Final Set, Jefferson Village Phase II  
(Bulletin 6)

JEFFERSON VILLAGE

TYPICAL PAVEMENT CROSS SECTIONS

HOR. SCALE: NO SCALE  
VER. SCALE: NO SCALE  
DATE: 3-27-00  
JOB NO.: DE99011  
FILE NO.: DE9911X1  
SHEET NO.: P-0.2

JEFFERSON VILLAGE  
 Neighborhood Development Corporation  
 ST. CLAIR AVE. STA. 150+00 TO STA. 161+00  
 PAVING - PLAN & PROFILE

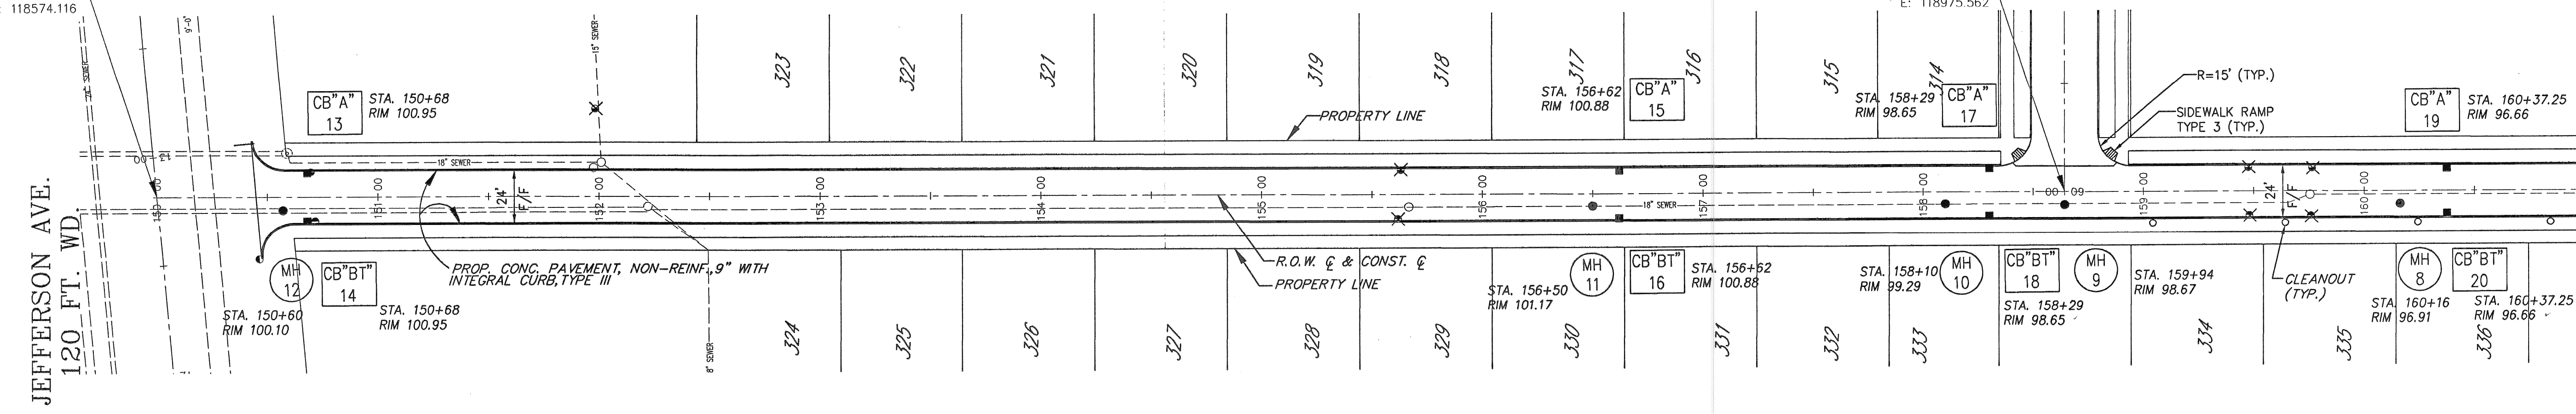
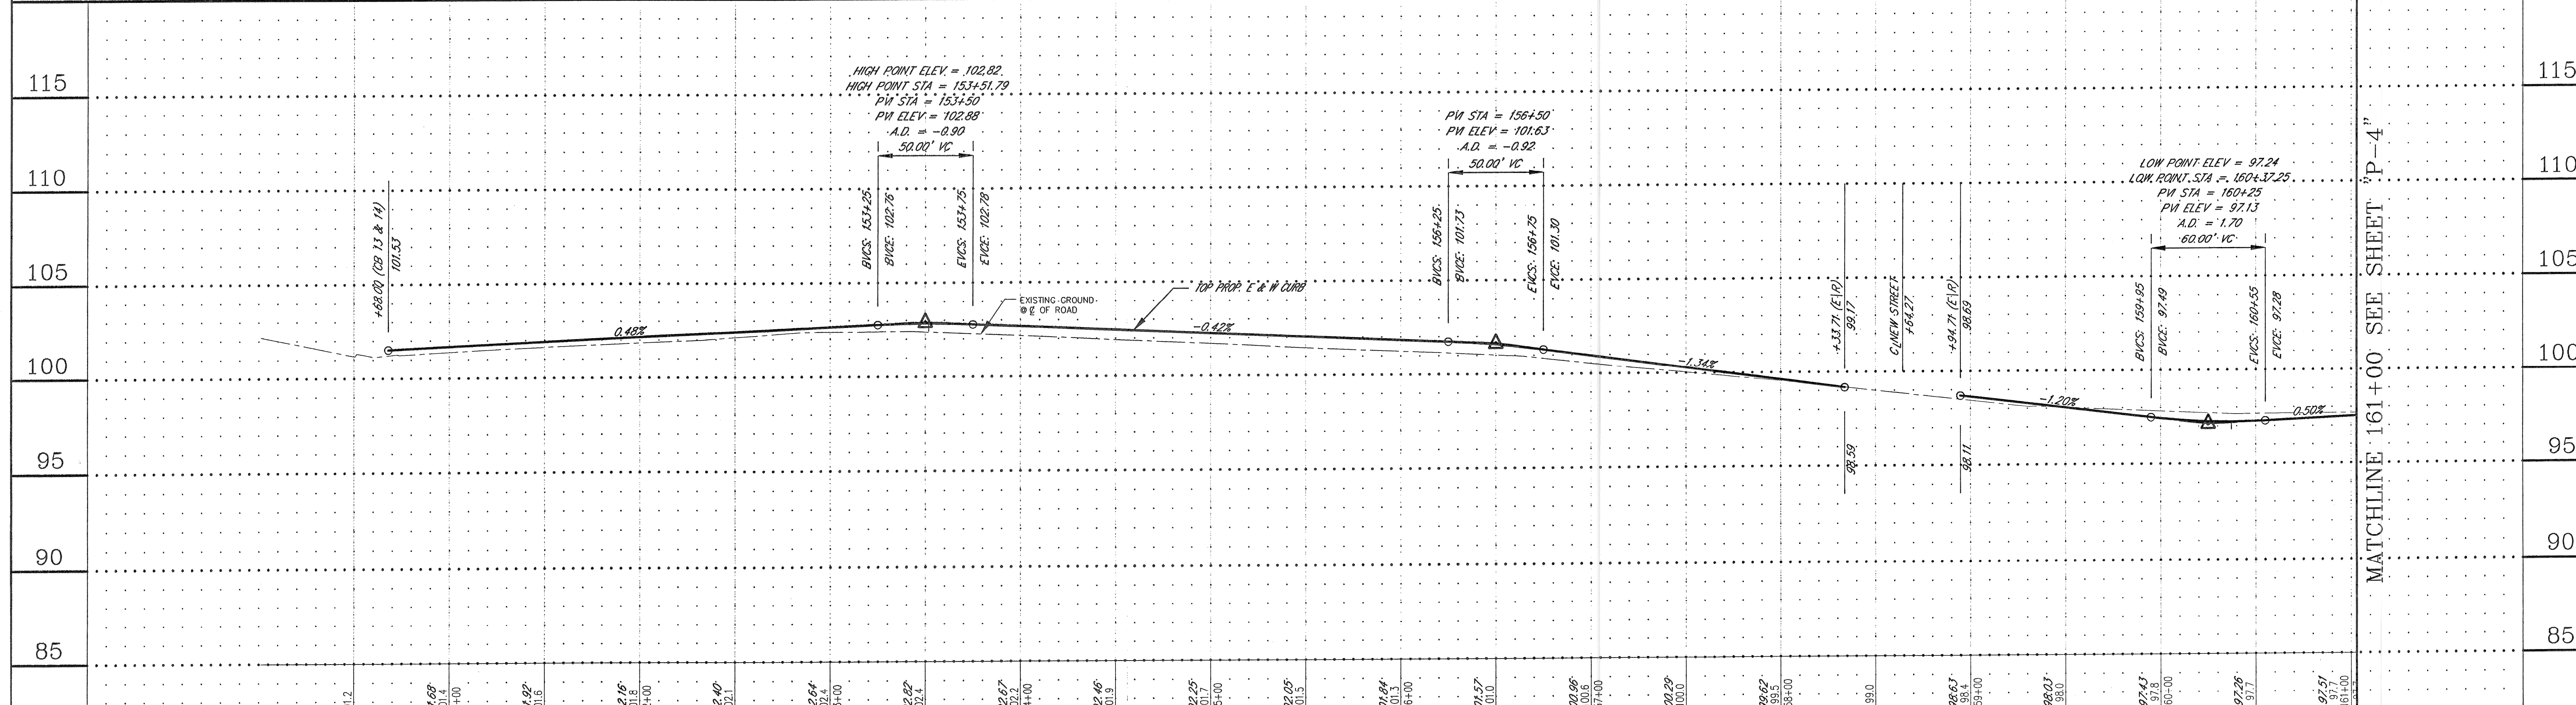
**NOTE:**  
 THE TYPE OF CURB WAS CHANGED FROM 7" HIGH STRAIGHT FACE TO 4" HIGH ROLLED CURB AFTER THE PREPARATION OF THE PAVING PLANS AND PROFILES (EXCEPTING FOR FREUD, MARQUETTE AND NEW STREET BETWEEN BENITEAU AND ST. JEAN). THE PAVEMENT ELEVATIONS AS SHOWN ON THE INTERSECTION DETAILS SHEETS SHALL BE MAINTAINED. ONLY THE TOP OF CURB ELEVATIONS SHALL BE DROPPED BY 0.25' (3"). THIS SHALL BE ACHIEVED BY SUBTRACTING 0.25' (3") FROM THE TOP OF CURB ELEVATIONS SHOWN ON THE PROFILES.

**NOTE:**  
 CB "A" 19 AND CB "B" 20 SHALL BE TRAPPED WITH THROTTLED COVER, TYPE B.

ST. CLAIR AVE. STA. 161+00 TO STA. 171+50  
 PAVING - PLAN & PROFILE

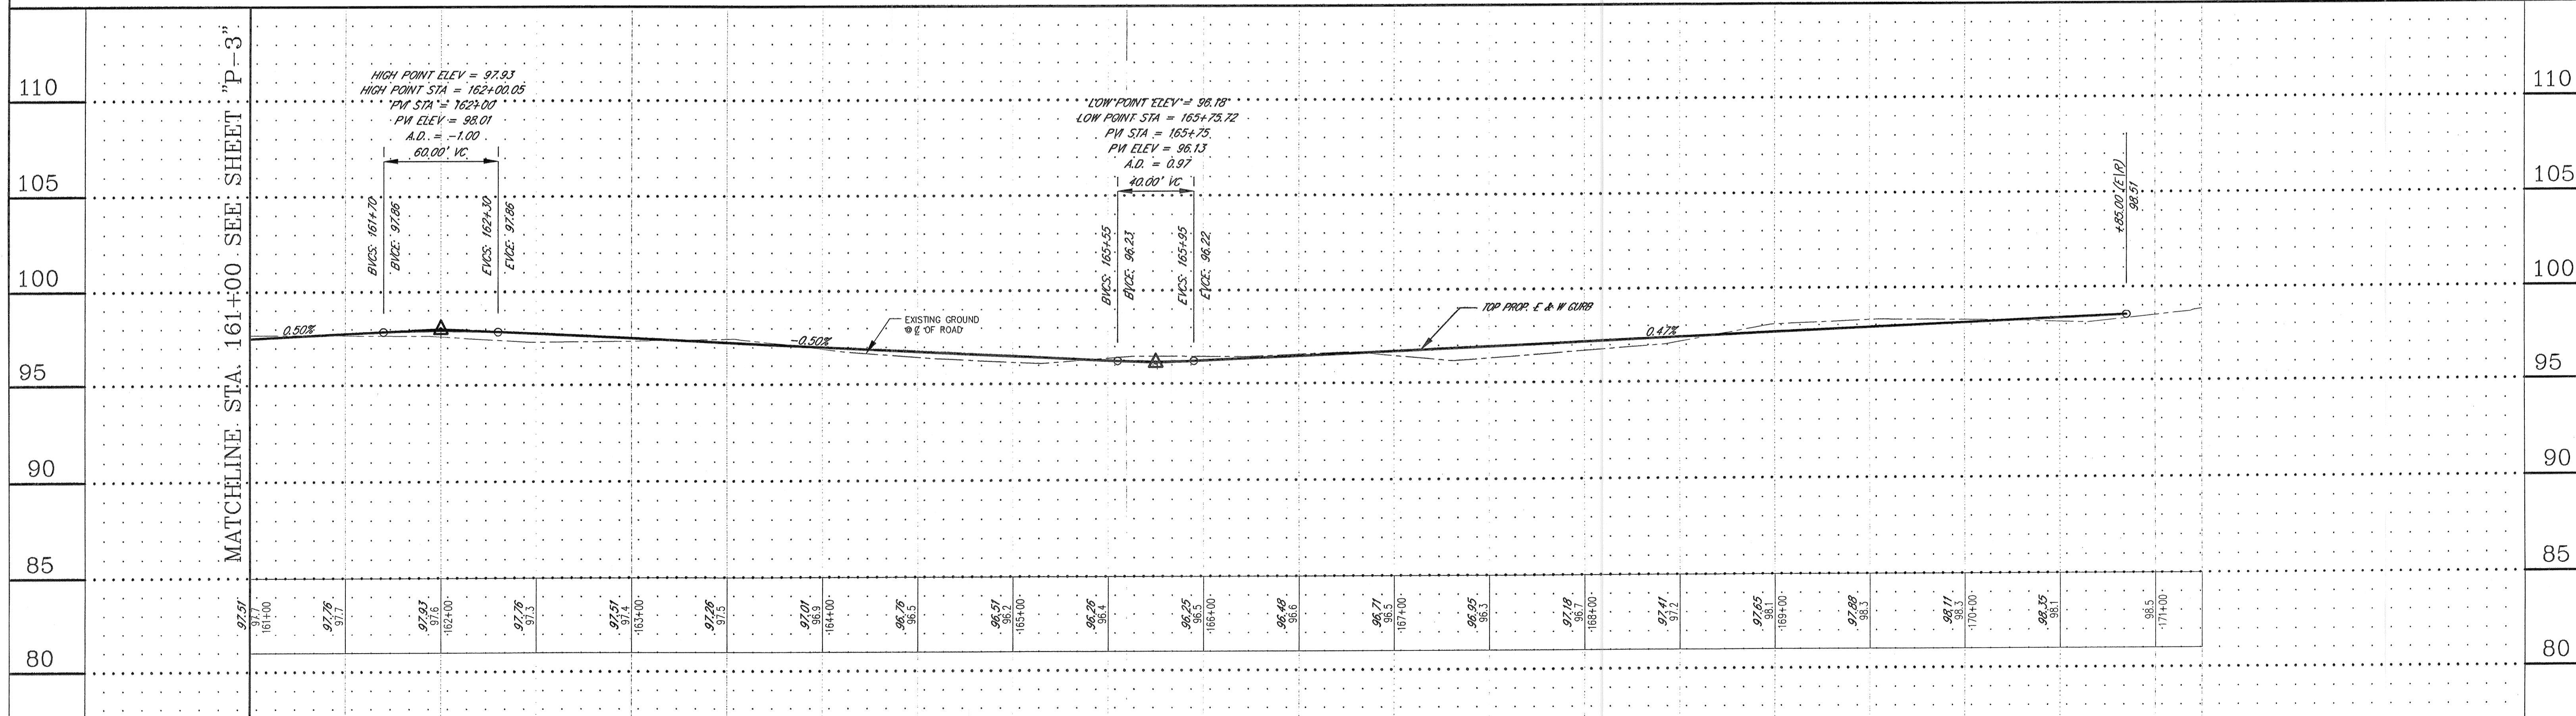
**NOTE:**  
 THE TYPE OF CURB WAS CHANGED FROM 7" HIGH STRAIGHT FACE TO 4" HIGH ROLLED CURB AFTER THE PREPARATION OF THE PAVING PLANS AND PROFILES (EXCEPTING FOR FREUD, MARQUETTE AND NEW STREET BETWEEN BENITEAU AND ST. JEAN). THE PAVEMENT ELEVATIONS AS SHOWN ON THE INTERSECTION DETAILS SHEETS SHALL BE MAINTAINED. ONLY THE TOP OF CURB ELEVATIONS SHALL BE DROPPED BY 0.25" (3"). THIS SHALL BE ACHIEVED BY SUBTRACTING 0.25" (3") FROM THE TOP OF CURB ELEVATIONS SHOWN ON THE PROFILES.

**NOTE:**  
 CB "A" AND CB "BT" SHALL BE TRAPPED WITH THROTTLED COVER, TYPE B.

SEAL  
JEFFERSON VILLAGE  
Neighborhood Development Corporation  
HARDING AVE. STA. 180+00 TO STA. 191+00  
PAVING - PLAN & PROFILE

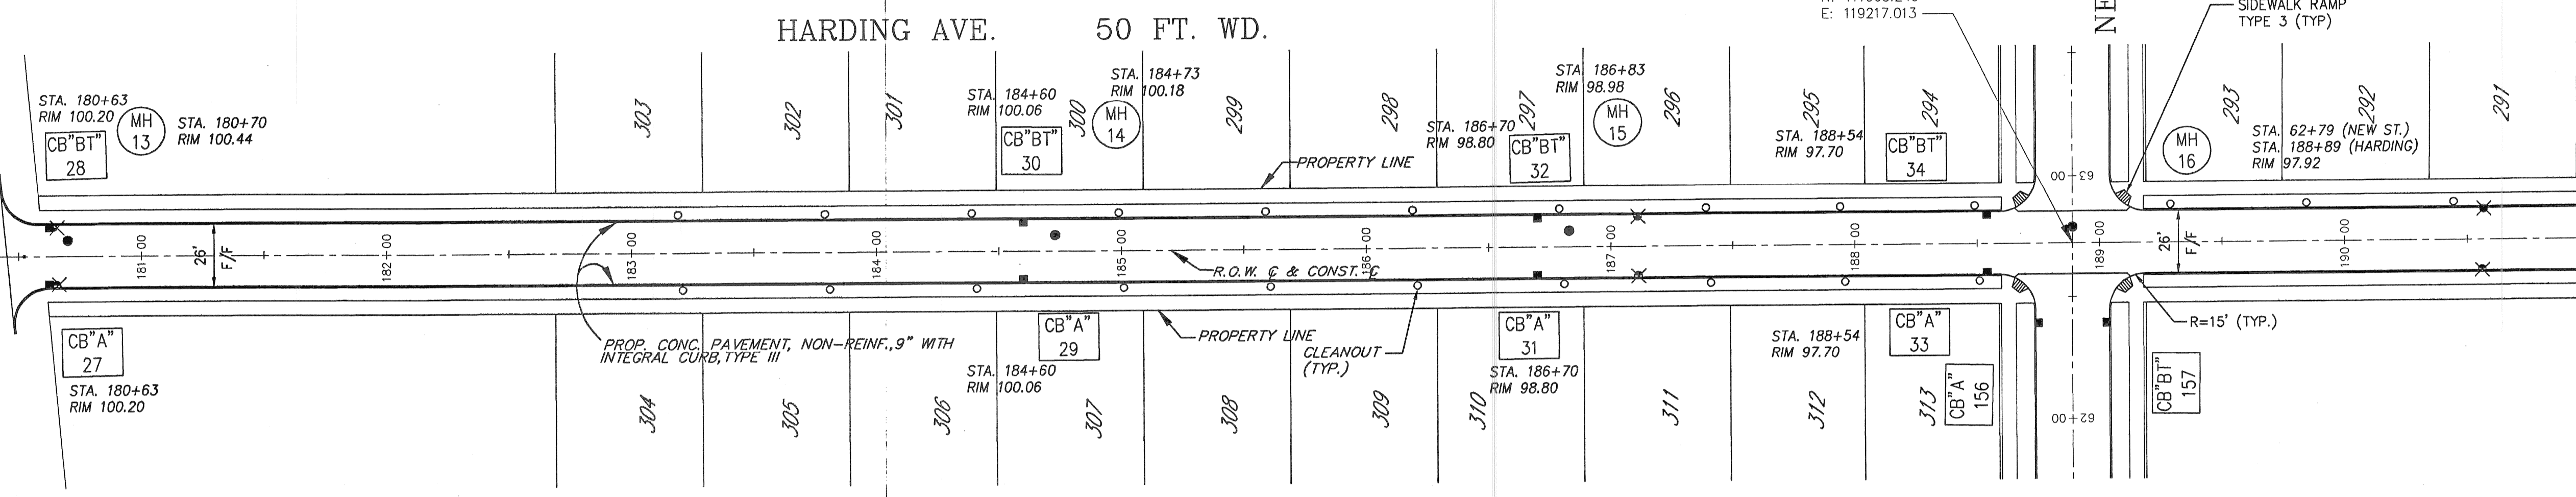
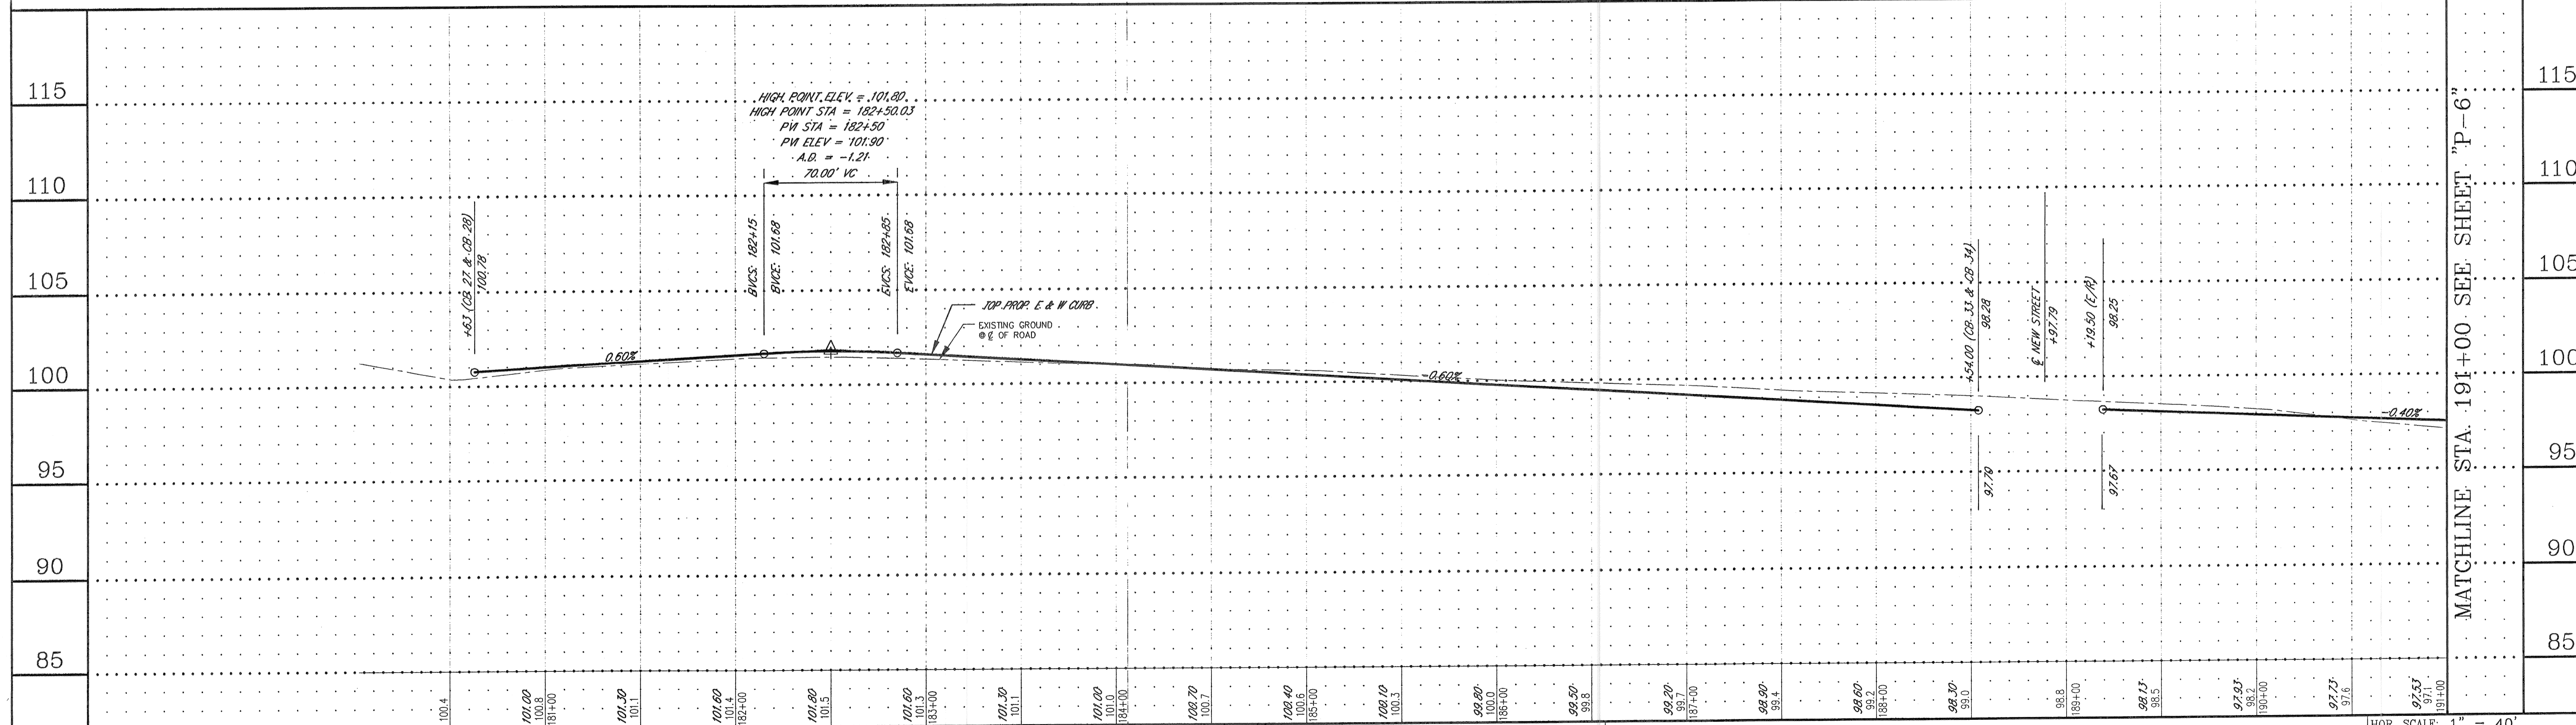
**NOTE:**  
THE TYPE OF CURB WAS CHANGED FROM 7" HIGH STRAIGHT FACE TO 4" HIGH ROLLED CURB AFTER THE PREPARATION OF THE PAVING PLANS AND PROFILES (EXCEPTING FOR FREUD, MARQUETTE AND NEW STREET BETWEEN BENVILLEAU AND ST. JEAN). THE PAVEMENT ELEVATIONS AS SHOWN ON THE INTERSECTION DETAILS SHEETS SHALL BE MAINTAINED. ONLY THE TOP OF CURB ELEVATIONS SHALL BE DROPPED BY 0.25' (3"). THIS SHALL BE ACHIEVED BY SUBTRACTING 0.25' (3") FROM THE TOP OF CURB ELEVATIONS SHOWN ON THE PROFILES.
